Report: Punch list
Function: Test, Adjust, & Balance
Date: 11/05/2025
Completed By: National TAB

11-03-25 Freddys - Versailles, KY

Issue List

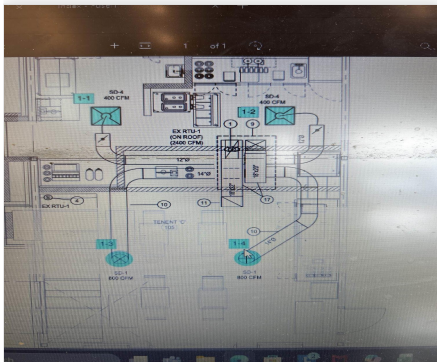
Issue Name : Hood HMI not functioning properly
Description : HMI controls both hoods with a single speed. They cannot be controlled independently of each hood. DRD mechanical wasn't to adjust speed. Fire suppression test on Friday. (11/7/25)
Created By : National TAB **Assigned To :** National TAB - Dan Hertenstein
Status : Open
Priority : High **Asset Tag :** HVAC EQUIPMENT1
Originated Date : 11/05/2025 - Jearod Ferrette - National TAB
